-						~					
LOC	Lockheed-california company			ENGINEERING STUDY:				I			
DATE	DATE 23 June 1971			AFFECTS: WSPO X PROJECT X							
NAME	NAME OF MAJOR COMPONENT PART Rucksack			OR LOWEST SUBASSEMBLY DN59324-1				PART NO. & MODEL OR TYPE PM59300-2A Survival Kit			
TITLE OF PROPOSAL: RUCKSACK INFLATION DEVICE MODIFICATION											
NATURE OF PROPOSAL:											
LAC proposes that the lever assembly, piston and packing presently used in the											
rucksack inflation device be replaced with newly designed components which will											
insure efficient operation of the unit.

ECP U-2R-75

RUCKSACK INFLATION DEVICE MODIFICATION

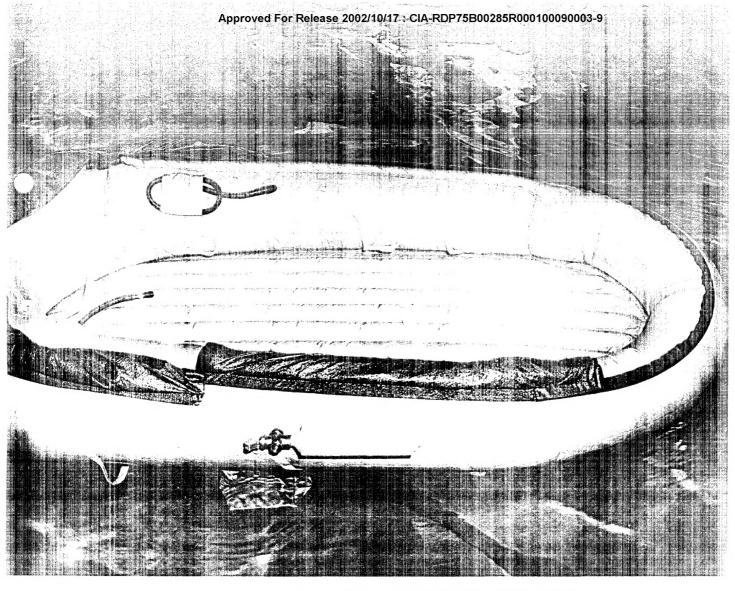
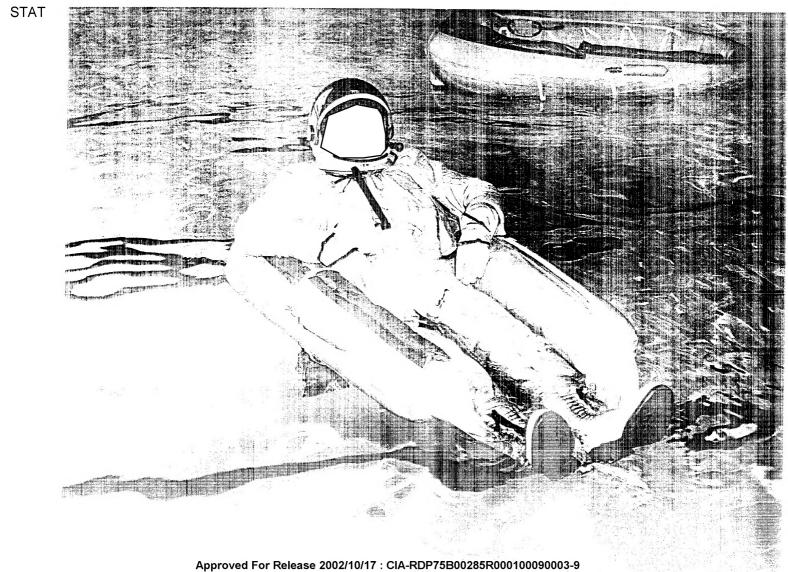
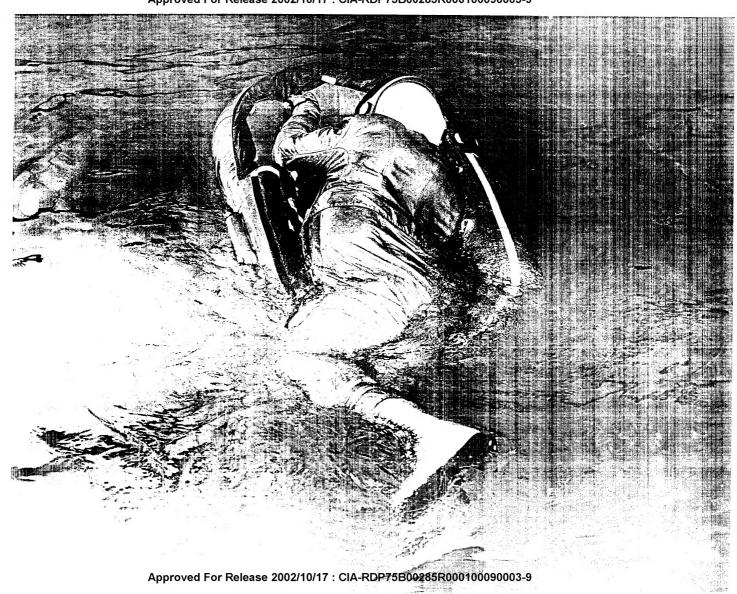
* A										
REASON FOR PROPOSAL:											
When the inflation device presently in use is actuated, gas escapes around the											
packing mounted on the piston thus diverting pressure from the rucksack. The											
newly designed components prevent this. Also, the new lever assembly and pis-											
ton are made of a harder material to withstand repeated actuation.											
	ESTIMATED COST AND TIME	INVOLVE									
ES	ADDITIONAL FUNDING REQUIRED:										
60	ESTIMATED COST FOR KITS	OR PART	S: See	Page 2	2			•			
CP	ADDITIONAL FUNDING REQU	JIRED ;	Non	ie.							
ITEMS AFFECTED BY PROPOSAL :											
SAFET		EDURE CHA	ANGE- WEIG	SHT &	TOOLS &	MAINTE- NANCE	SERVICE LIFE	FLIGHT MANUAL	MAINTE- NANCE		
X		ז c		ANCE	UIPMENT	PROCEDUR			MANUAL		
EST. MAN/HRS. REQ'D. TO ACCOMPLISH CHANGE IN FIELD											
SOURCE OF PARTS FOR KIT AVAILABILITY XXXX WEEKS AFTER APPROVAL											
SRA Modification Kit P/N DN-D431-1137-1 See Page 2

Provide Service Bulletin Kits to replace the existing lever assembly, piston and packing in thirty-one (31) Rucksack Assemblies.
